Determination 2017/087¹

The refusal to issue a code compliance certificate for a 19-year-old house with EIFS wall cladding at 184 Adams Road, RD1, West Melton

Summary

Figure 2: Diesel tank site requirements

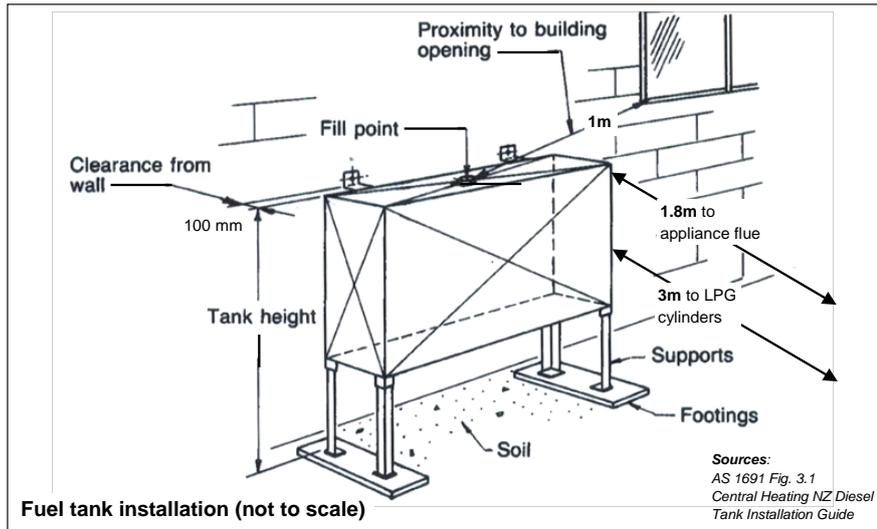
6.4.1 The 460 litre fuel tank is located behind the detached garage (see Figure 1). The expert assessed the location of the tank against the requirements of AS 1691 Section 3. Oil Fuel Tanks¹³. Minimum separation distances required from adjacent construction are shown in Figure 2:

6.4.3 In regard to the tank installation, the expert noted that (in summary):

- The tank rests on a bed of compressed gravel, with no concrete footings.
- AS 1691:1985 made no mention of seismic restraint but requires a strip of concrete under the steel legs at each end.
- Current requirements call for a fuel tank to be seismically restrained and to stand on a 100mm thick concrete slab.
- If concrete pads were to be provided, tank legs may be bolted into the pads to provide seismic restraints (see Figure 2).

6.4.4 The expert’s recommendation was that a concrete foundation should be provided to support the tank.

7.9.3 In regard to seismic restraint of the diesel fuel tank and taking account of the current requirements of C/AS1 Part 7, I note the expert's recommendation is that concrete foundations should be installed, with the tank support legs to be bolted into the concrete in order to provide appropriate long term earthquake resistance. The applicant may wish to consider this step along with the maintenance items that have been recommended (but that are not required to achieve compliance).
